DESCRIPTIVE REPORT

~~XXXXXXXXXX~~ } Sheet Nos 18, 19, 20, 21  
Hydrographic }

Calibogue Sound

DESCRIPTIVE REPORT TO ACCOMPANY HYDROGRAPHIC SHEETS

Tracing from  
H-5569 (1933)  
(Field No. 20)

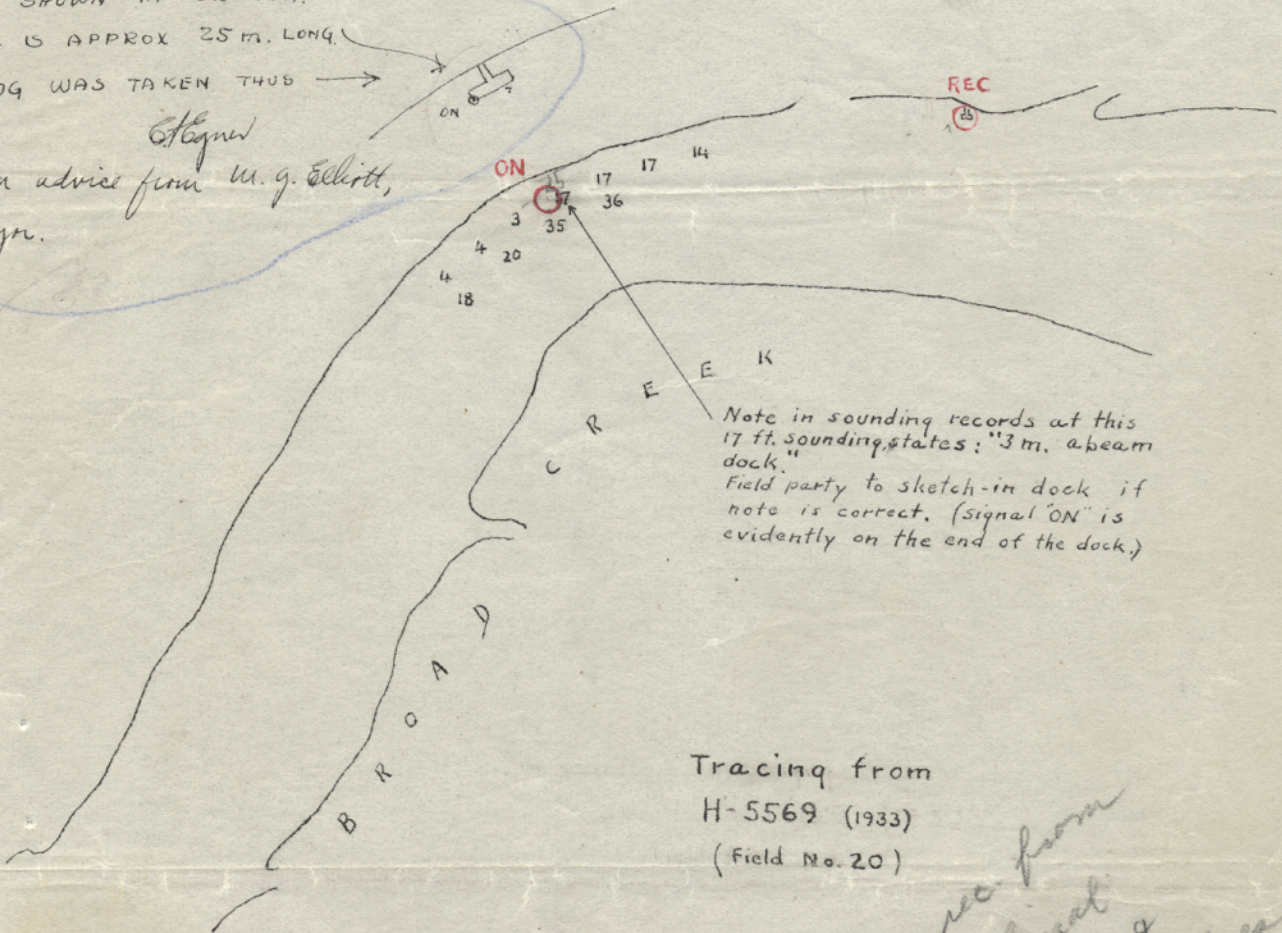
\* c. Topo. signal "Rec" at lat.  $32^{\circ}10.85'$ , long.  $80^{\circ}46.62'$  was originally shown on the smooth sheet by the field party as on the end of a dock. The only authority for signal "Rec" is the Boat sheet for the present survey which was evidently used as a plane table sheet for cutting in this and a few other signals which fall outside the limits of the contemporary air photo control sheet. The air photo compilation sheet (H-5212) does not show a dock at this signal but does show one about 40 meters to the westward. Some doubt therefor exists as to the correct location of signal "Rec" which is of importance since it was used in the hydrographic development of the area. The matter has been referred to the field party for further information. \* Signal "Rec" not on dock, correctly shown on smooth sheet. See letter attached.

Dock as originally shown on smooth sheet by field party. (Now deleted.)

DOCK IS APPROX 25 M. LONG.

*Signed*  
upon advice from W. G. Edlitt,  
Surveyor.

TRACING FROM H-5569  
(MACKAY CREEK & BROAD CREEK)

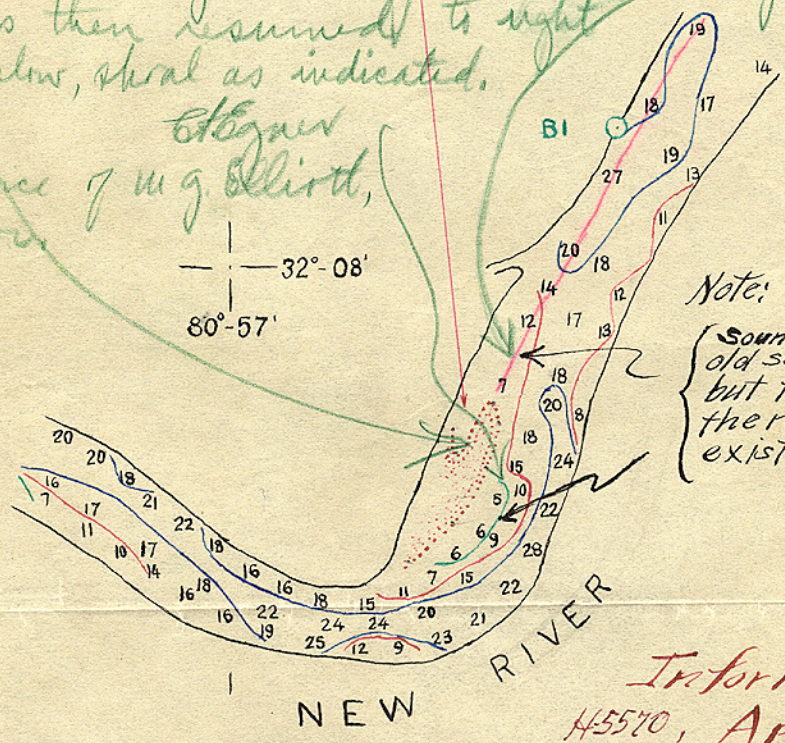
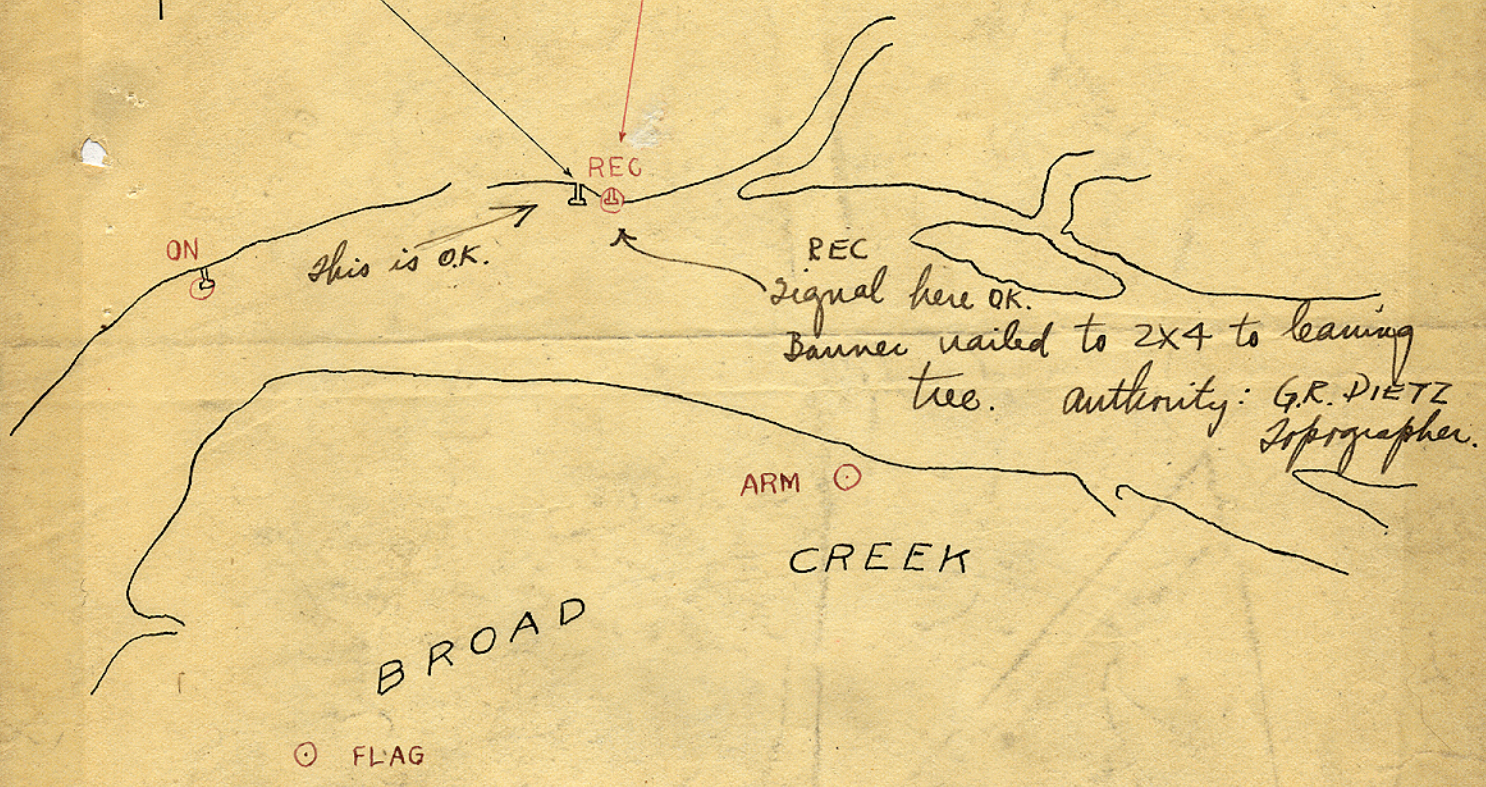
Note: Sounding lines adjacent to old sand bar run at low water, but there are no notes in the record indicating the existence of the bar.

Bar is still there as indicated. Sounding line was run until grounding occurred beyond 7' Vsdg. Line was then resumed to right of, and below, shoal as indicated. *Obtained upon advice of W. G. Elliott, Surveyor.*
